## **DRIFTWOOD ACRES SUBDIVISION, BLOCK B, FIRST ADDITION, RESUBDIVISION OF LOTS 10A AND 10B**

Engineering Comments: FINAL PLAT COMMENTS (should be addressed prior to submitting the FINAL PLAT for review and/or signature by the City Engineer):

The applicant is requesting Subdivision approval to create two (2) legal lots of record from one (1) existing legal lot of record.

# DETAIL SITE PLAN

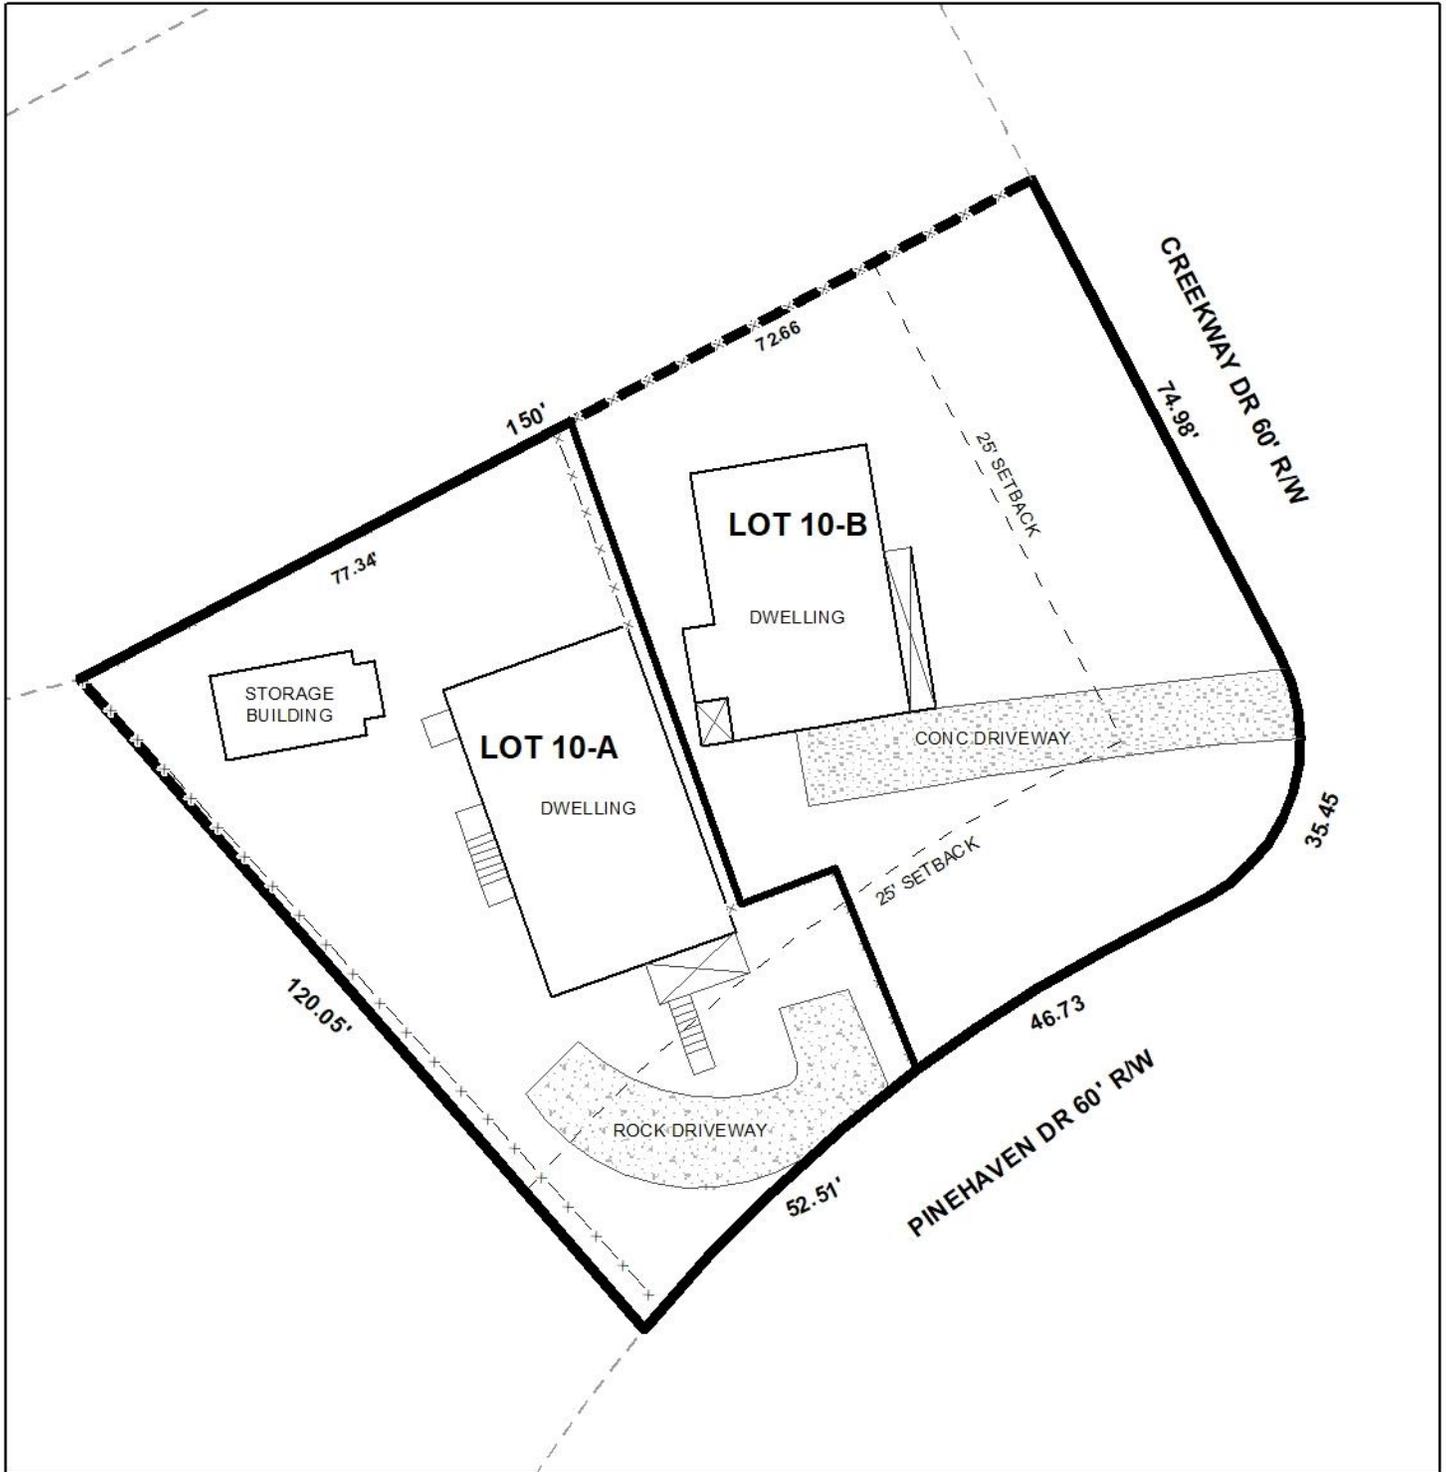
The site has frontage on Pinehaven Drive and Creekway Drive, both minor streets without curb and gutter, and have an existing, compliant 60-foot right-of-way; therefore, no dedication should be required. As on the preliminary plat, the rights-of-way width of Pinehaven Drive and Creekway Drive should be retained on the Final Plat, if approved.

The preliminary plat submitted indicates a proposed 25-foot minimum building setback line along both frontages, and this should be retained on the Final Plat, if approved.

The proposed Lot 10-B exceeds the minimum size requirements of the Subdivision Regulations; however, the proposed Lot 10-A is approximately 475 square feet less than the minimum standard set forth in Section V.D.2. of the Subdivision Regulations. It should be noted that there do not appear to be any other sub-standard size lots in the area, however in this instance creating separate lots for the existing dwellings is preferred over the continuation of the existing zoning violation, therefore a waiver of Section V.D.2. of the Subdivision Regulations may be appropriate. If approved, the Final Plat should be revised to illustrate lot sizes in both square feet and acres, or provision of a table on the Final Plat providing the same information.

The preliminary plat does not depict any existing easements on site. However, if any easements are present on the site, if approved, a note should be placed on the Final Plat stating that no structure is allowed in any easement, without the approval of the easement holder.

Regarding access management, a note should be placed on the Final Plat stating the Traffic Engineering comments, if approved.

- 1) retention of the right-of-way width of Pinehaven Drive and Creekway Drive on the Final Plat;
- 2) retention of the 25-foot minimum building setback lines along Pinehaven Drive and Creekway Drive on the Final Plat;

- 3) retention of the lot sizes in both square feet and acres, or provision of a table on the Final Plat providing the same information;
- 4) placement of a note on the Final Plat stating that no structure is allowed in any easement, without the approval of the easement holder, if applicable;
